EXXON GETTYSBURG

The EXXON GETTYSBURG is expected to enter Newport News Shipyard in May to undergo repairs and alterations. We request that you prepare necessary engineering designs for: (I) conversion of the aft potable water tank and all applicable piping in the amidship square to a sewage holding system, (II) installation of a FAST treatment system and alteration of sanitary piping in the after house, and (III) modification of the cargo manifold. This work will be included in specifications sent at a later time by our repair department, but is being sent in advance to allow time for engineering designs to be developed and approvals processed.

EXXON GETTYSBURG - 1978 SHIPYARD SPECIFICATIONS

SEWAGE RETENTION - AMIDSHIPS - MODIFICATION

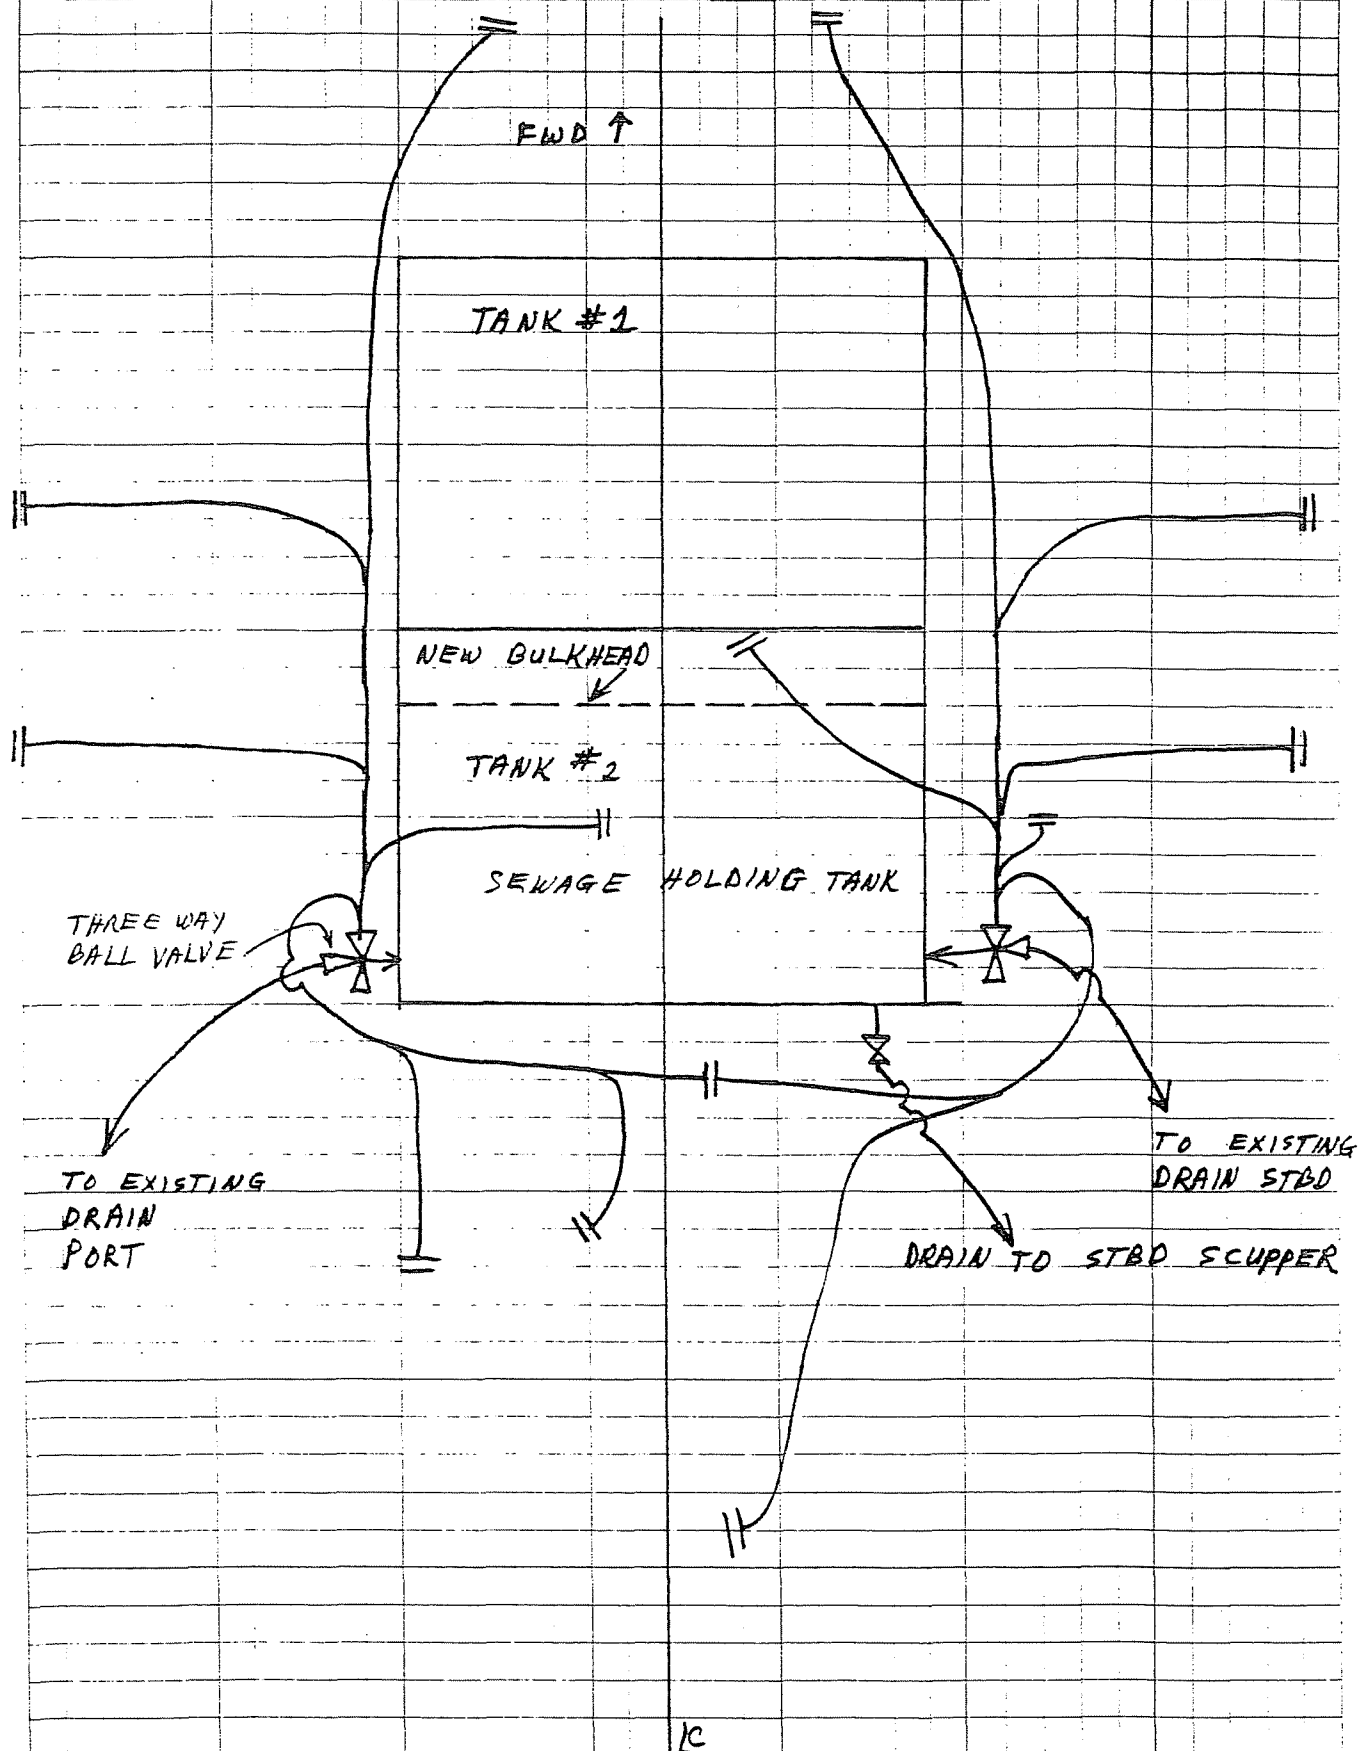
Furnish labor and material required to modify the existing sewage overboard discharge system to incorporate the use of the aft potable water tank in the amidship square as a sewage holding tank. The system is to be complete with tank level and alarm system, saltwater washdown system and tank self-drainage system. The modified sewage system is to be capable of going overboard or to the holding tank.

Modify the sewage piping system to direct black water to the holding tank or overboard (see sketches). One (1) three-way ball valve port and one (1) three-way ball valve starboard are to be provided and installed to allow waste to be directed overboard or to the tank. A single overboard drain line is to discharge through the starboard five inch scupper. Insure that all newly installed drain lines are properly sloped (at least 1/4" drop per foot of pipe run).

Fabricate and install a new forward bulkhead in the aft potable water tank in the amidship square. Allow approximately two feet between the new bulkhead and the existing tank bulkhead. Cut lightening holes between the two bulkheads as necessary. Disconnect the aft potable water tank from the potable water system and seal all connections as required. Remove the aft tank sounding petcocks and seal permanently. The interior of the tank is to have surface preparation of white metal blast (SS SA3), then apply two (2) coats of rust ban 6692 black coal tar epoxy or equal 8 MDFT each coat (16 MDFT total). Tank exterior in the disturbed area is to have needle gun preparation, then apply one (1) coat rust ban 188 or equal 2 to 3 MDFT, one coat rust ban 6566 or equal 1-1/2 to 2 MDFT, and two (2) coats rust ban 6403 or equal 1-1/2 to 2 MDFT each coat (3 to 4 MDFT total). Furnish and install a five inch drain system from the tank to the starboard scupper. Supply and install piping and valve. Construct a suitable manhole access centered over the suction penetration tailpiece. Extend the existing tank vent to a suitable location above deck.

Furnish and install a tank level and alarm system to alarm in the ship's cargo office and indicate tank level. Level switches are to be suitable for hazardous environment. Three switches (DeLaval Gems Series LS 1950 where approved) are to be used which will indicate liquid level in the upper tank zone. Install a saltwater spray down system in the holding tank supplied from the ship's saltwater service system. Install a back-flush line to the tank suction tailpiece, also from the ship's saltwater service system.

EXXON GETTYSBURG - AFTER HOUSE FAST SYSTEM INSTALLATION

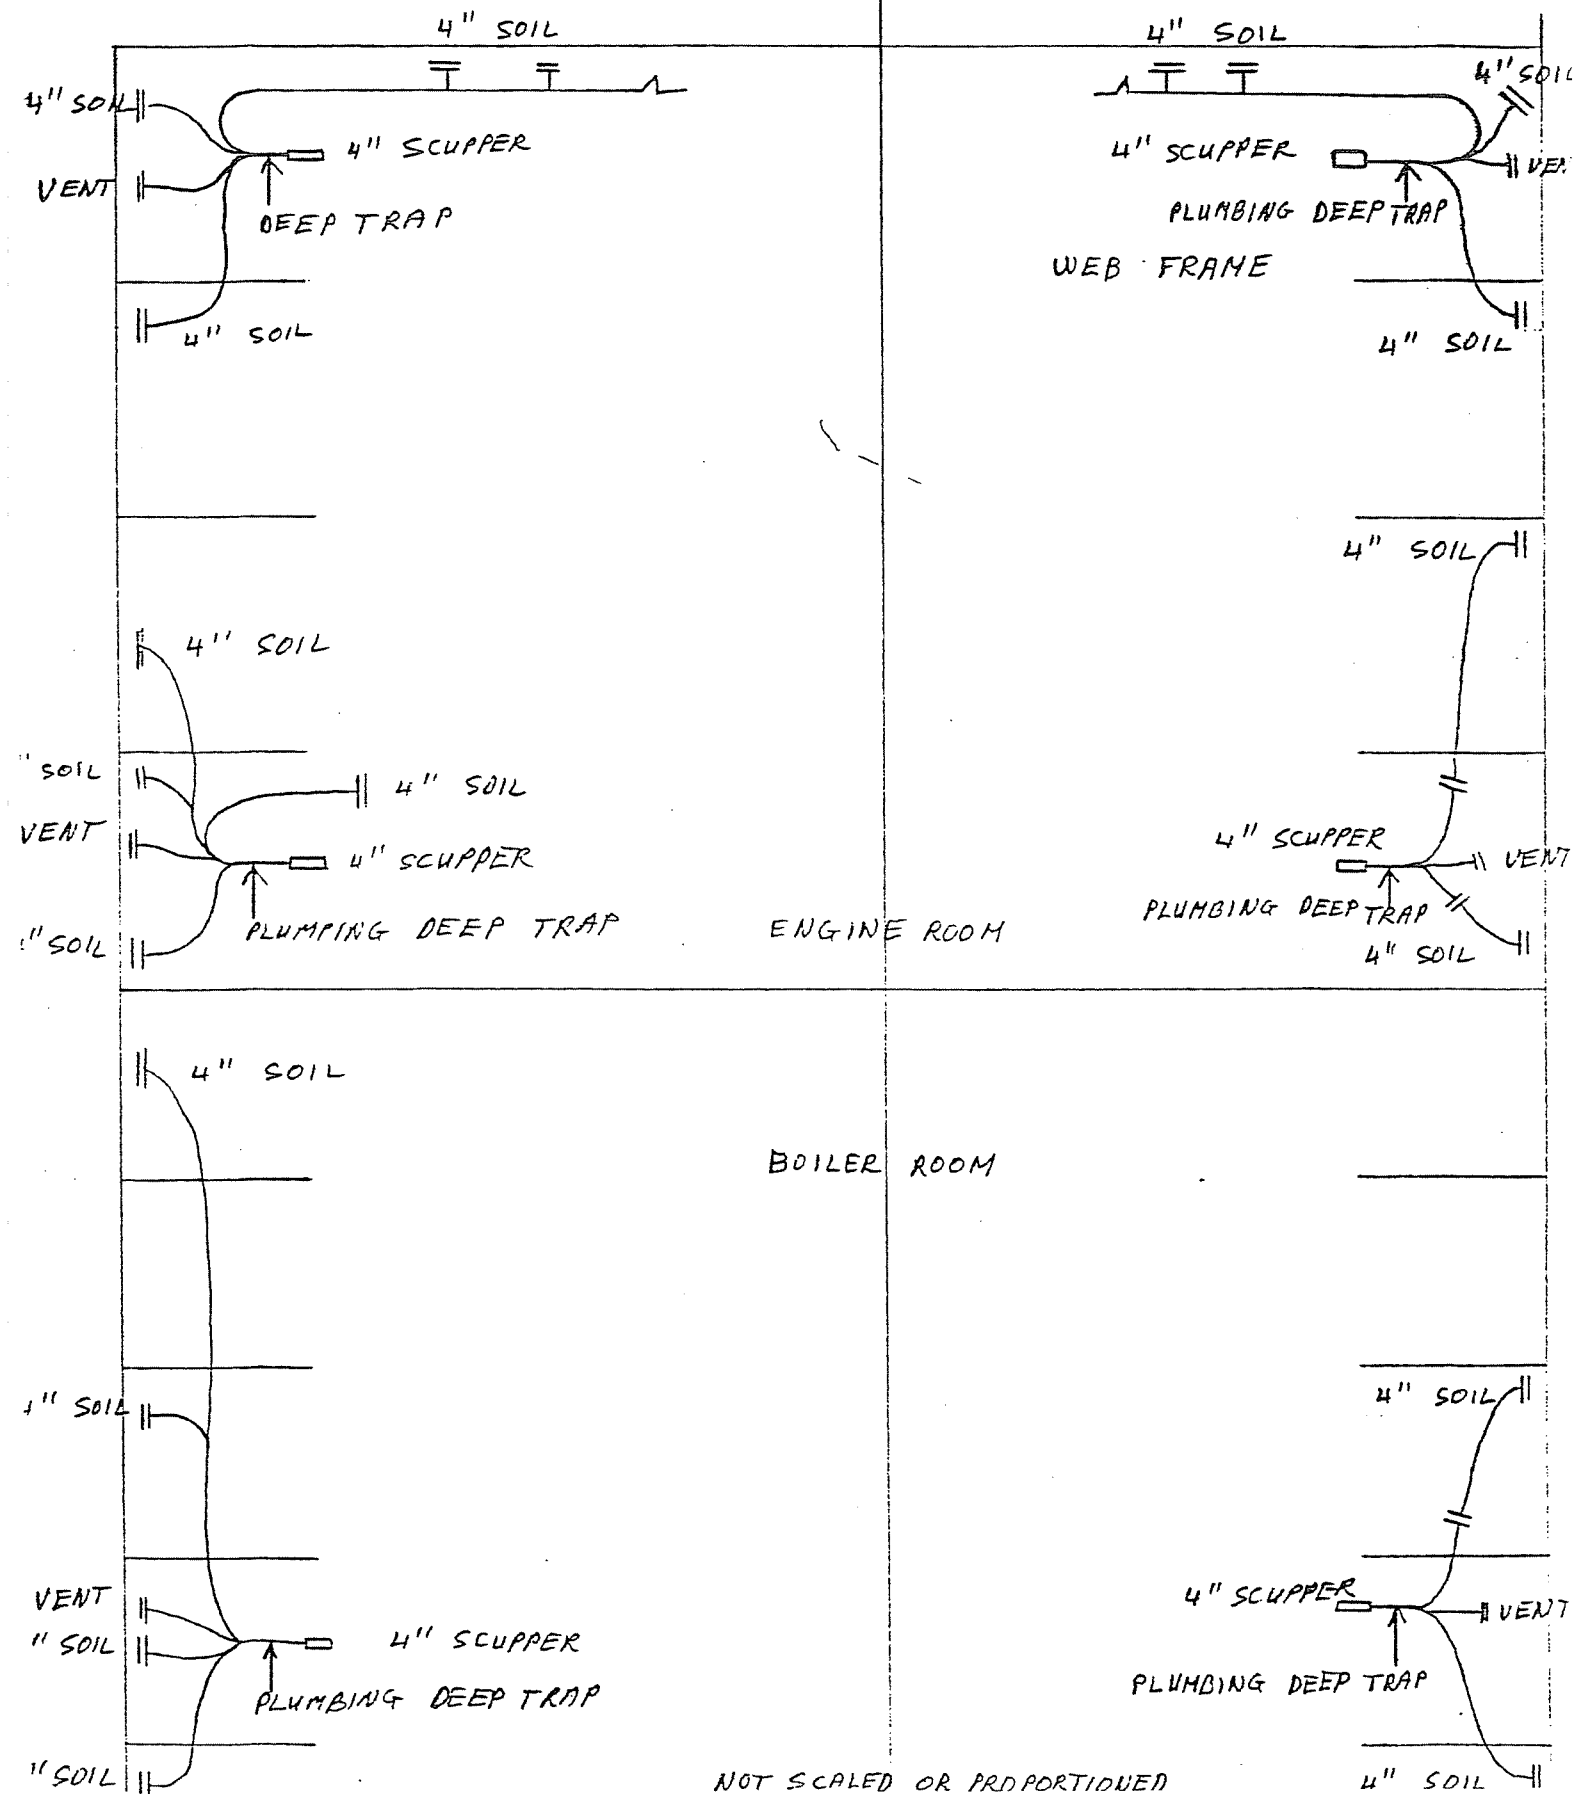
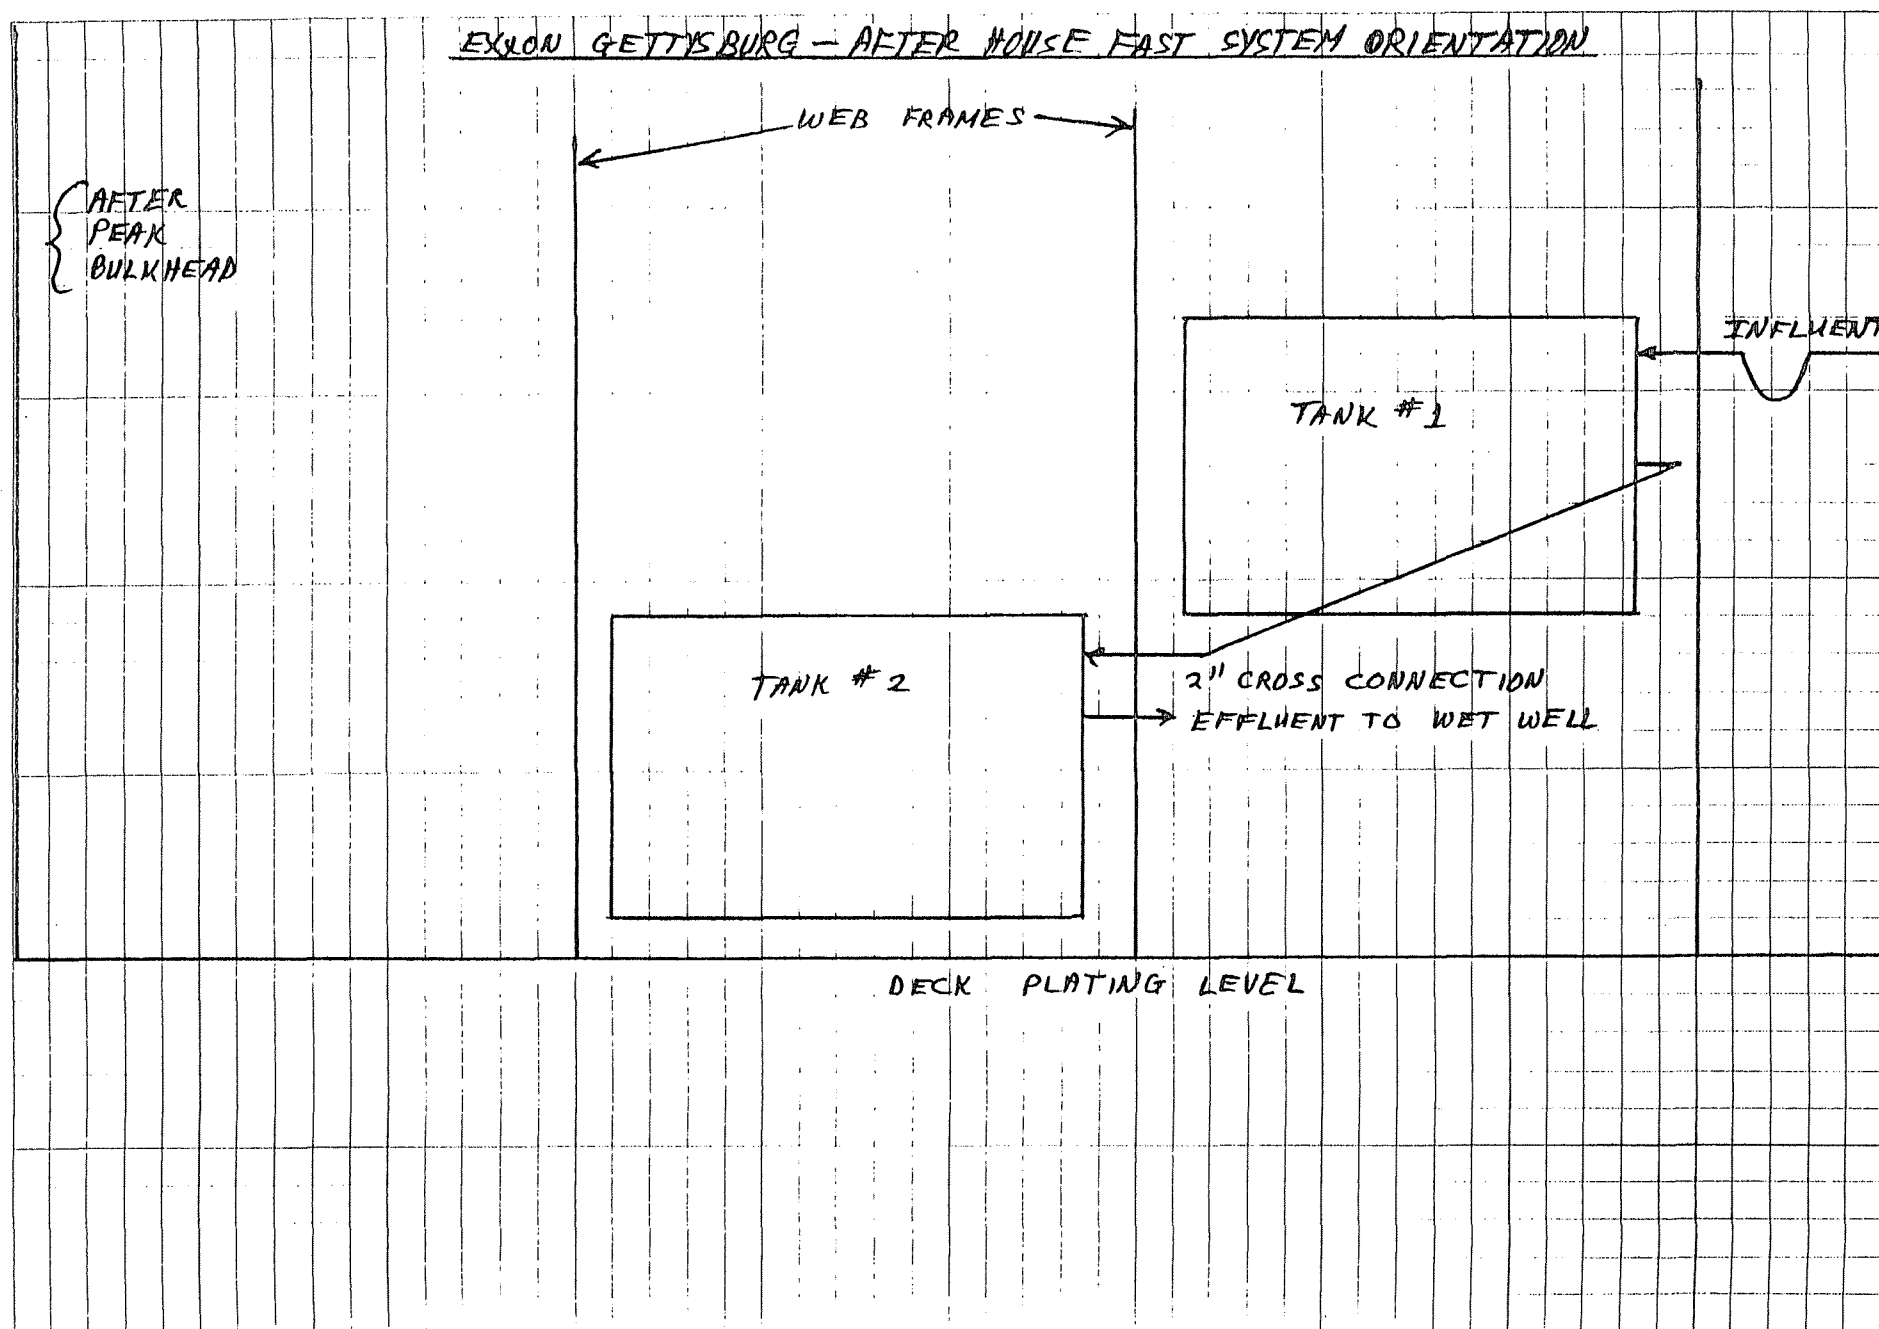
Furnish labor and material required to modify the existing sewage overboard discharge system and to install one FAST treatment system (FAST 26M owner furnished) on the port side of the lower engine room space, in the 20-40 frame area (see sketch). Obstructing piping and equipment are to be relocated as necessary. The FAST system is to be installed as per the manufacturer's guidelines. The modified sewage system is to be capable of going overboard or to the FAST system.

Remove the toilet shared by the two deck maintenance rooms on the starboard side (between frame 16 and 18) and cap the 4" drain line.

Modify the sewage piping system as per the sketch attached. Cut a total of eighteen (18) 4" soil lines in the engine room and plug or cap the remaining pipe leading to the six scuppers (seven cuts starboard and eleven port). Install 4" piping on both sides of the engine room to modify the system as sketched. Install two (2) 4" three-way ball valves port and two (2) 4" three-way ball valves starboard. Valves are to be able to direct waste overboard through the center scupper (one port and one starboard) and the after scupper (one port and one starboard) or to the FAST treatment system. Insure that all newly installed drain lines are properly sloped (at least 1/4" drop per foot for pipe running aft or athwartship, and at least 3/8" drop per foot for pipe running forward). Piping is to be FRP where approved (Ameron Bondstrand). Shipyard to gain approval.
